ADDENDUM TO

Tree survey to BS 5837 (2012): with constraints and impacts

Land fronting Naildown Close, Hythe, Kent

Report: 171004 ADDENDUM v5 dated 27 October 2017.

Tree protection plan

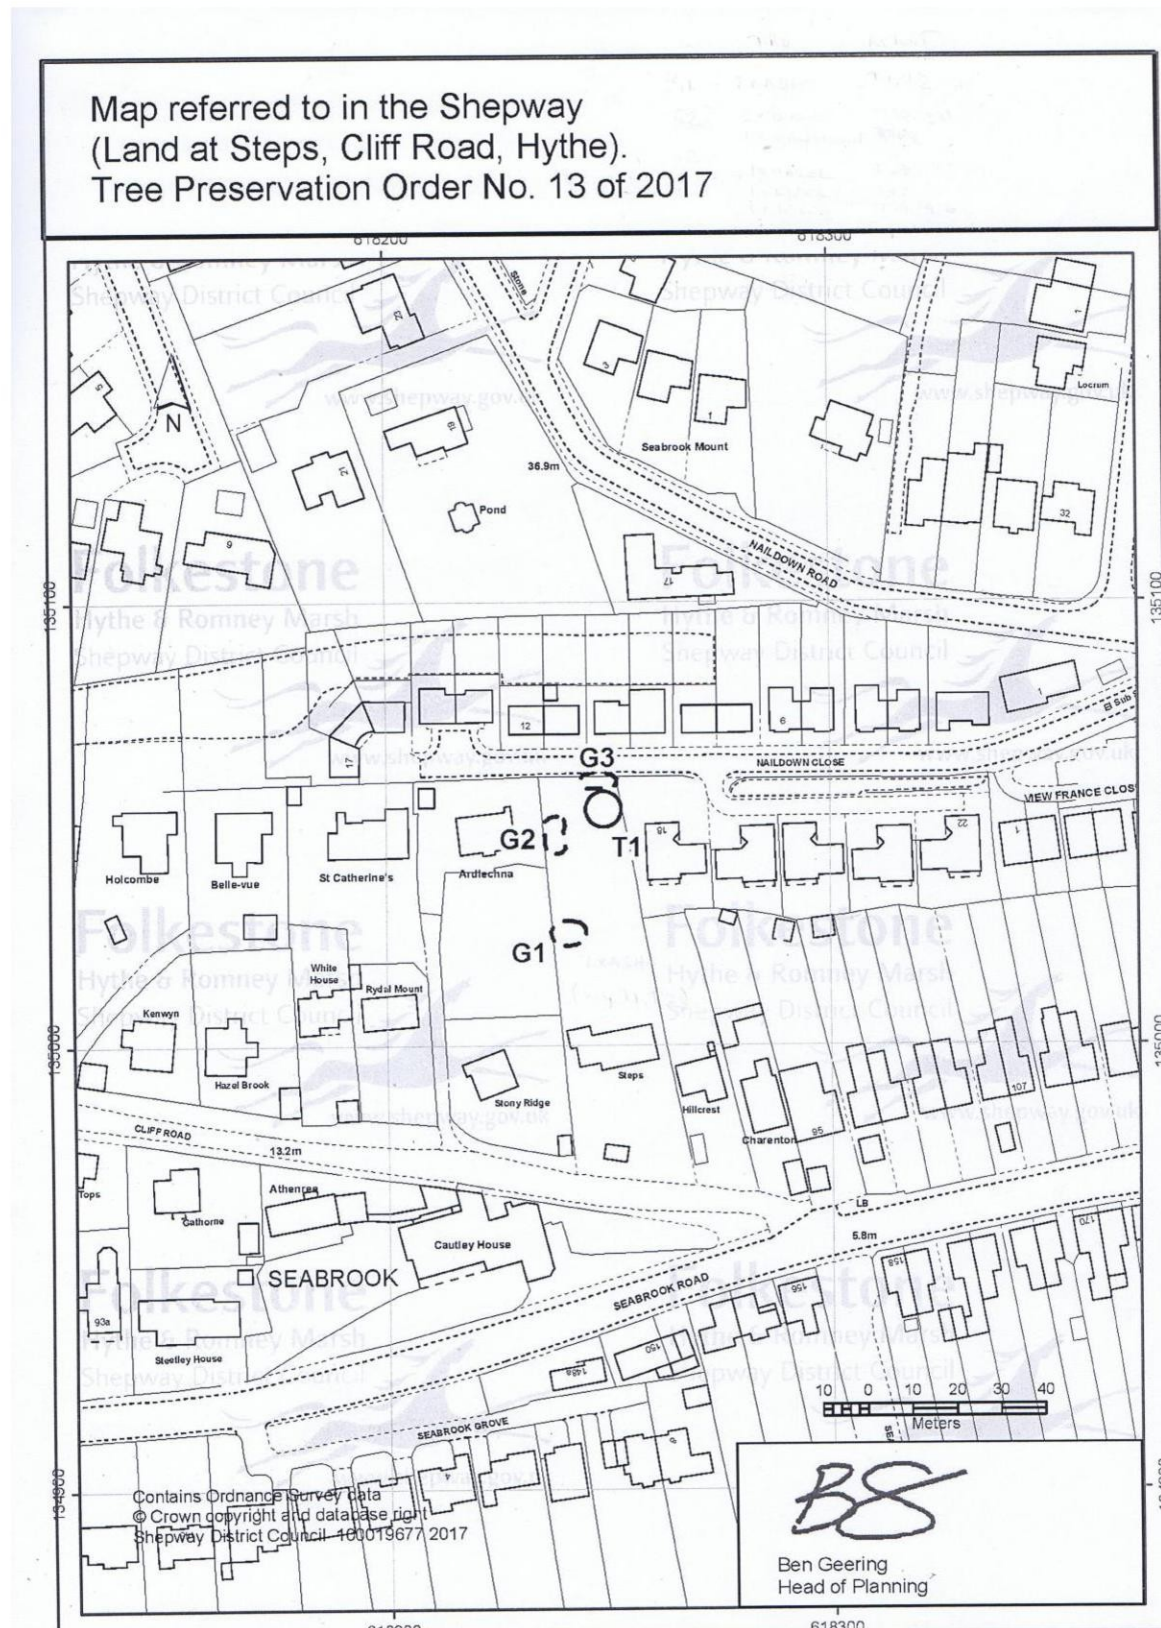
I allow 1m clearance from the dwelling footprint and drain run, 3m clearance at the north-west and south-west corners of the proposed dwelling to allow for access to the rear. The consequence is that the fencing is well within the RPAs of T12 Hawthorn and T20 Mulberry, necessitating ground protection in addition to the fencing.

Ground protection panels such as 'instant roadway' protect underlying roots from damage and permit traffic within RPAs. The area shown on the plan is the minimum area. It may be convenient to increase it depending on the size of the panels.

Only the turning head on the west side of the site may be levelled for the panels (by lowering the level on the north side), otherwise the ground level is to be reduced by no more than 20cm to increase evenness. It is good practice to put down a layer of wood chip, which also helps to even out the surface and spreads load. Ground protection is also required within the scaffolding for the north elevation. Ground protection should come as close as practicable to the excavation for the foundation.
